Please find my concerns and objections to the proposed development at 164-194 William Street Woolloomooloo. It was very difficult to put together a considered reply to the development application given the 59 attachments consisting of over 2,000 pages for a very complex proposal when it was only on public exhibition for 14 days.

**Development Application:  
Nos.164-194, William Street, Woolloomooloo  
Visual Impact Assessment Report, October, 2023.**

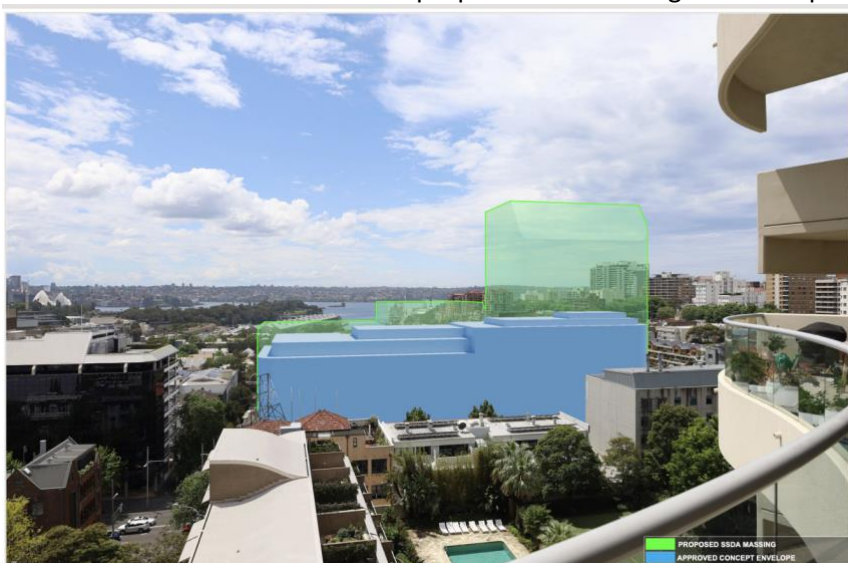
They have not provided any information on the total extent of the visual impact to my apartment which I would rate as moderate to severe based on the Tenacity scale.

Below is my current view as per the developers 2025 visual impact assessment. The difference between the first image and the 3<sup>rd</sup> image is substantial.

Below is the view with the developers requested 30% extra height on top of the extra height for the 'park'.

Below is the view with the current proposal which is a significant impact.

Figure 3: Alternative 30% uplift option, which reduces external impacts

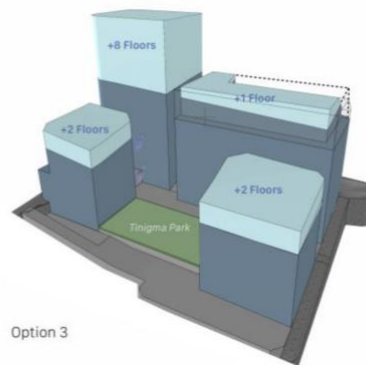
When you compare the park image with the building design model, the park seems to be much larger than the claimed 1,356sqm? But it does look pretty..... If I was a rough sleeper, I would give it a whirl because it looks a lot nicer than where they currently sleep in Forbes Street. The reality is that the park will be surround on 3 sides by the apartment buildings (figure 3 above) and will be in shadow for most of the day and windy as per the wind report.

As you can see, the inclusion of the park has now afforded a very significant number of apartments with spectacular views towards the harbour, Opera House and Bridge. This greatly increases the sale value of these apartments and developer returns.

Figure 6: Pedestrian wind speed measurement locations with comfort/safety ratings – Initial Scheme

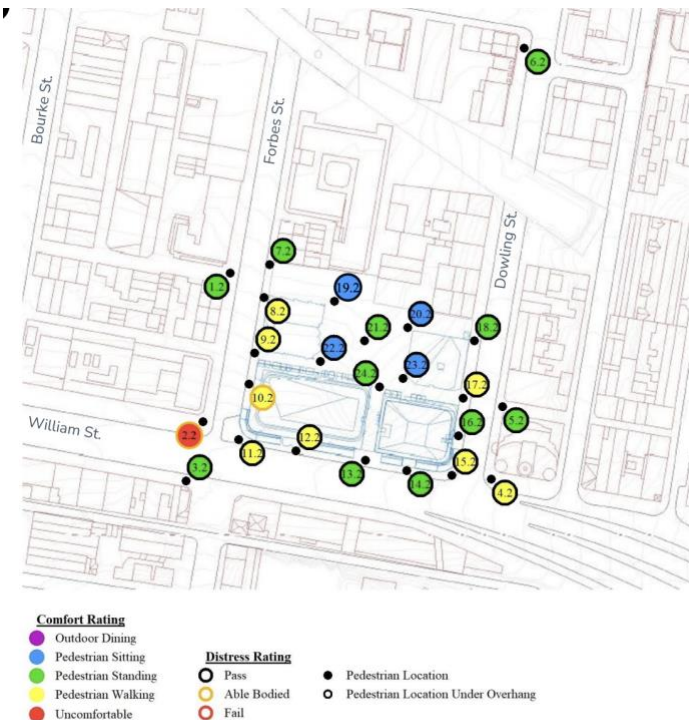
On Page 18 they have identified the areas they measured for wind impact for the proposed building. You can see that the new ‘park’ is not comfortable for outdoor dining. The pedestrian seating is only practical in the corners of the park. There are a lot of pedestrian standing areas, but do people really want to come to a park and stand?

Figure 6.2: Service Vehicle Routes

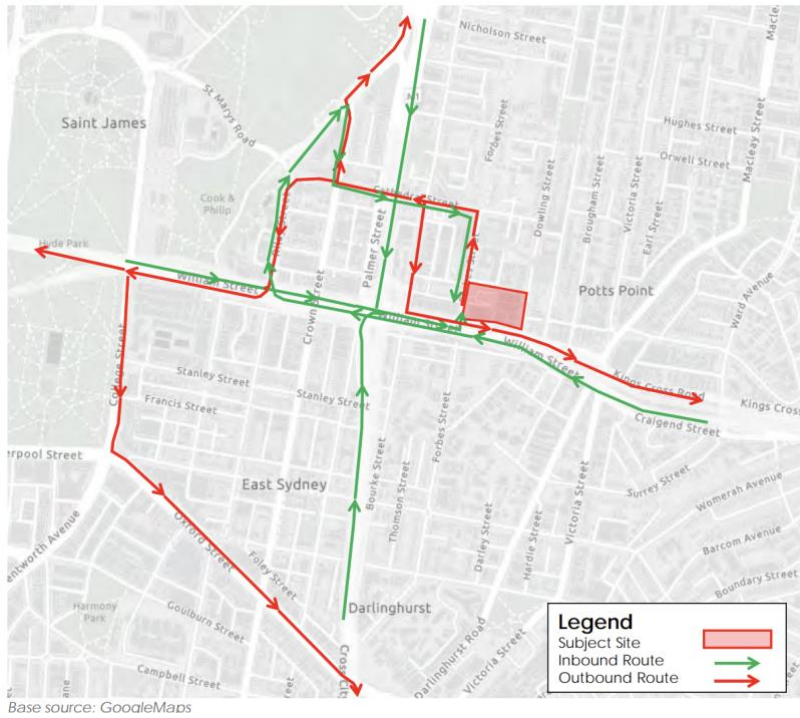
Page 25 - This suggests vehicles will turn right into William St from Bourke Street – which is a no right turn. Alternatively, they are trying to show they are coming from the Eastern Distributor exit. This section of William Street between Forbes and Bourke Sts is congested for most of the day with vehicles blocking the intersections in frustration of trying to turn into the street. This will likely result in forcing traffic to go through the narrow local back streets of Woolloomooloo.
